Product Notice

Notice: #090723

Date: July 31st 2009

The package height as documented will change from 0.260 +/- 0.01" to 0.265 +/- 0.01" (a less than 2% adjustment in mean height). As an example, the 'earlier' and 'revised' package dimensional drawings for BCM products are attached, and the relevant dimension shown below:

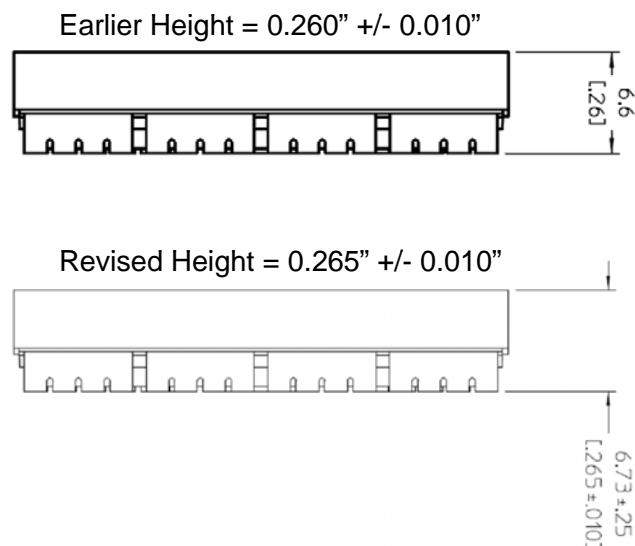
This is a change to documentation only, to reflect actual dimensions. There are no changes to the product itself.
